200 MAY -2 11 0:01 NUCLEAR ENERGY INSTITUTE

Subject: Draft Final Technical Study of Spent Fuel Pool Accident Risk at
Decommissioning Nuclear Power Plants, February 22, 2000 (65 F.R.
8752), Request for Comments

**Industry Comments
NRC Draft Final Technical Study of
Spent Fuel Pool Accident Risk at
Decommissioning Nuclear Power Plants**

**Comments on Appendix 2.b.
"Structural Integrity Seismic Loads"**

Figure 1 – Distribution of Upper Bound Magnitude Estimates from Reference 2 for a New England site.

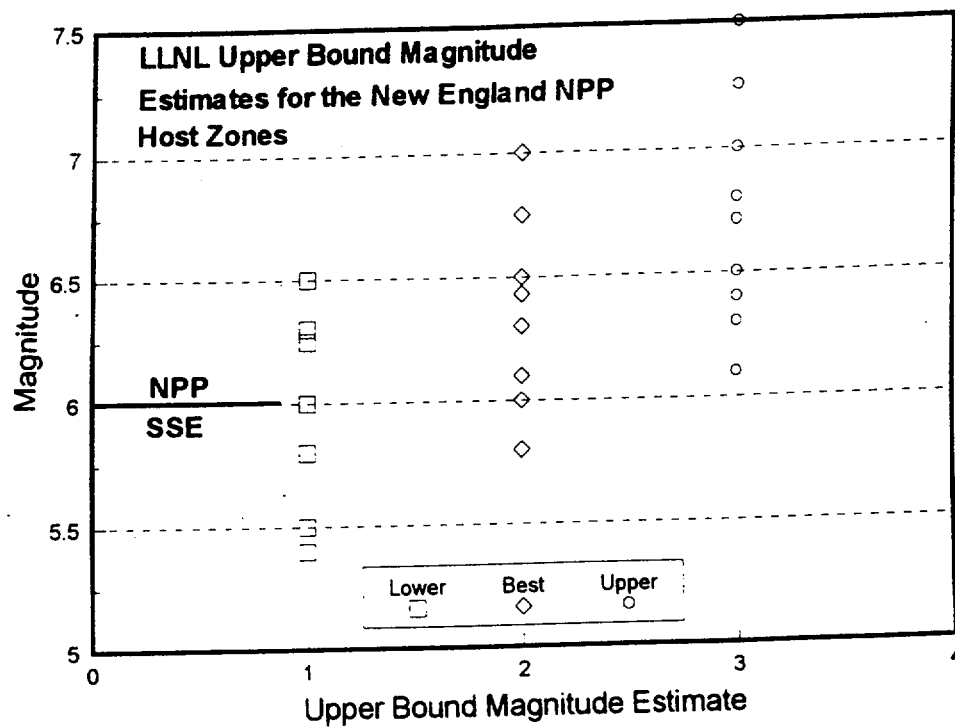
References 2 and 3 describe the Lawrence Livermore National Labs (LLNL) and Electric Power Research Institute (EPRI) seismic hazard methodologies. A seismic hazard analysis (SHA) estimates the seismic hazard at a site due to the potential occurrence of earthquakes in the region surrounding the site. Importantly, the historic seismic data is insufficient, at least for the CEUS, to use as the sole source of information for estimating the various parameters of the overall probability model. Therefore, it is necessary to rely on "expert opinion" to supplement the data. One fundamental expert opinion input to the SHA is the upper bound magnitude distribution for each earthquake source. Figure 1 contrasts the distribution of upper bound magnitude estimates assessed by the experts in the LLNL study for the host zones containing a New England NPP with the SSE determined by the 10CFR Part 100 Appendix A process. This distribution of upper bound magnitude may be plausible, but not necessarily a possible outcome. In other words, it is not based on any known structure in each host zone description that could cause earthquakes this large. Within this context, the assessed seismic hazard will generally be higher – because less is known and the distribution has more probability associated with extreme outcomes, or, outcomes that in fact cannot occur. The effect of including these extreme outcomes is to predict incredible ground motions at credible probability levels. Expert opinion on the distribution of upper bound magnitude is but one of the many opinions rendered in the LLNL and EPRI studies that have profound effects on the perceived seismic hazard at low (10^{-6}) probability levels.

Figure 2 Effect of Attenuation Random Uncertainty on Probability of Exceedance from a Point Source

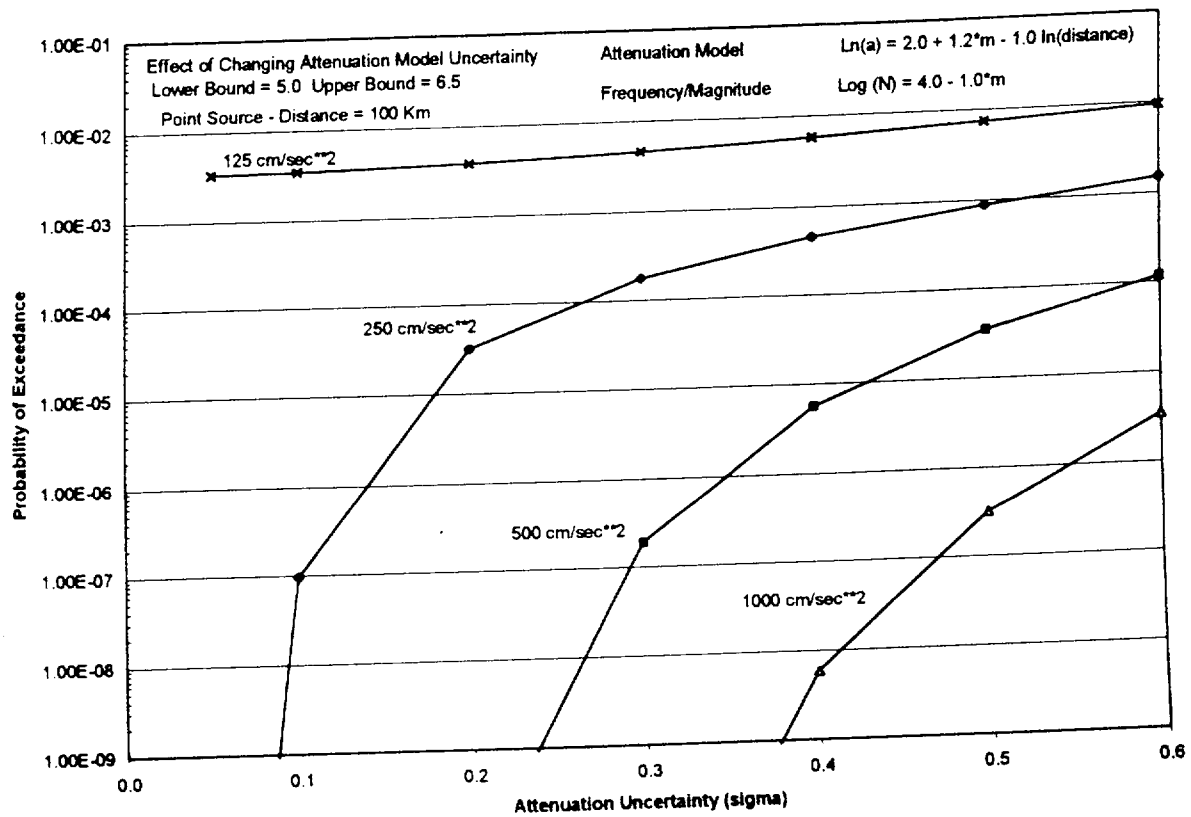
Successful application of the revised seismic checklist provides a high degree of assurance that the SFP HCLPF is 0.5g or greater. It is noted that given a HCLPF of 0.5g the median capacity of an SFP is about 1.0g. Realistically, only large Charleston like earthquakes can generate ground motions of the amplitude, frequency content, and duration to challenge the seismic capacity of spent fuel pools. In no EUS licensing proceeding has there been compelling data to require design to an earthquake of a magnitude which would challenge the seismic capacity of an SFP that satisfies the seismic checklist. The focus of previous seismic hazard studies (LLNL and EPRI) has been at the SSE level. At high ground motion values (ground motion values that can be associated with damage to SFPs), the tail of the attenuation random uncertainty distribution (sigma) allows, with some non-negligible probability, relatively small events to contribute to the

probability of exceeding these high ground motion values. These results don't make sense and provide a basis for truncating the tail of the random uncertainty term at high ground motion values. In deterministic analyses used in the licensing of existing NPPs, one standard deviation is considered sufficient to incorporate all the conservatism in the final ground motion estimate. Based on this information and information previously described in Reference 5, use of the LLNL probabilistic estimates at low probability values may not be credible. EPRI results are also likely to be overly conservative at high ground motion values.

Figure 3 – Annual Probability of Exceeding the SSE at CEUS sites based on EPRI (Reference 3)

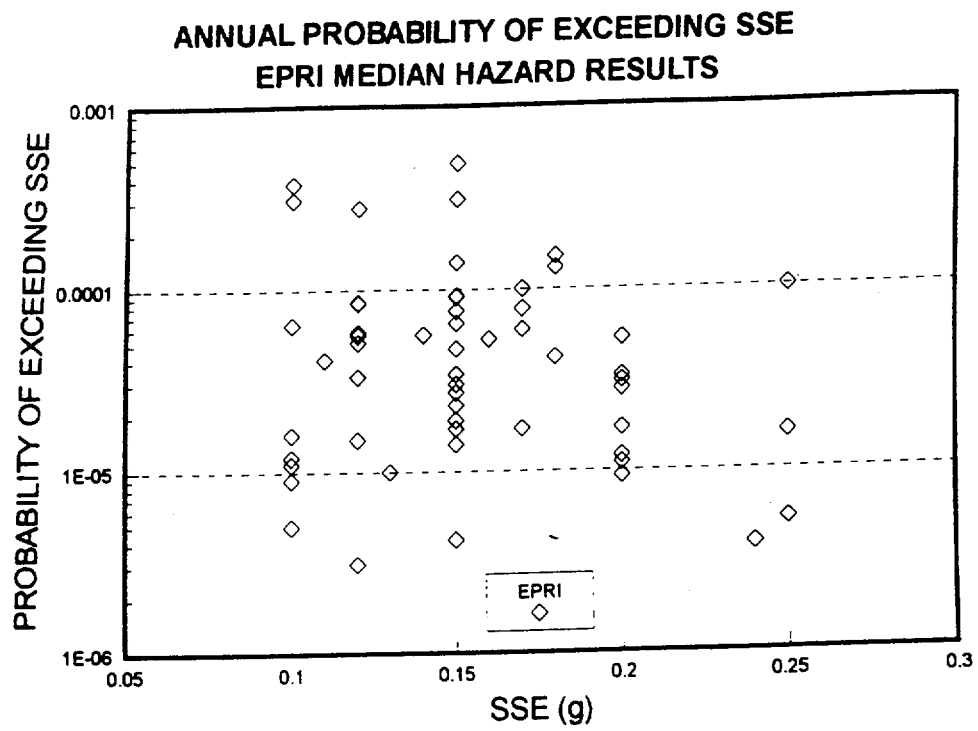
The staff concludes that for those CEUS plants where 3 X SSE is less than or equal to the NEI screening criterion of 0.5g, then the seismic risk is acceptable low. A similar conclusion is reached for those WUS plants where 2 X SSE satisfies the screening criterion. For CEUS plants that exceed the 3 X SSE screening criterion, a detailed SFP assessment will be required to demonstrate the SFP HCLPF equals 3 X SSE. A similar conclusion is reached for those WUS plants where 2 X SSE exceeds the screening criterion. This requirement that some plants with higher SSE values perform detailed HCLPF assessments of their SFPs is not warranted. The assumption of this requirement is that the SSE is correlated with seismic hazard, in other words, the higher the SSE the higher the seismic hazard. Previous studies have shown that the SSE is poorly correlated with the seismic hazard (see Figure 3). In particular, there are many 0.2g to 0.25g SSE sites with lower seismic hazard estimates than 0.1g to 0.2g SSE sites. SSE tends to be more correlated with plant vintage than seismic hazard. **Based on this information, we**

conclude that there should be no SFP screening level distinctions based on plant SSE for the CEUS. For the WUS, it is reasonable to require that certain plants demonstrate a HCLPF of 2 X SSE.
